Wrightsoft response to Staff Comments July 27 2017

**Staff Comments concerning Right-Energy® Florida 2014.
July 25, 2017**

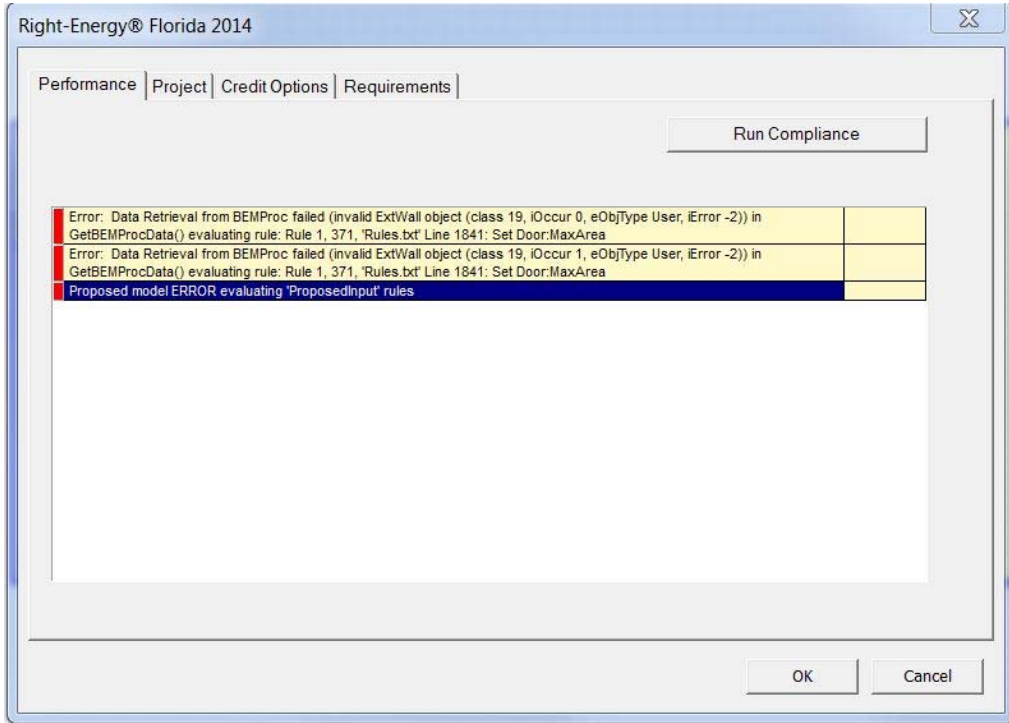
1) Does this program work for Additions or existing homes? Is there a way to specify different areas for compliance. (I.E. separating an existing home from an addition. Or adding an addition to existing mechanical equipment.)

Response: In our submittal letter requesting approval we indicated that this version is seeking approval only for New Construction, Single Family detached houses. We fully intend to submit a later extended version which addresses additions and multi-family residential. Once we have resolved any issues from this submittal and we gain approval, we will continue work to submit the extended version.
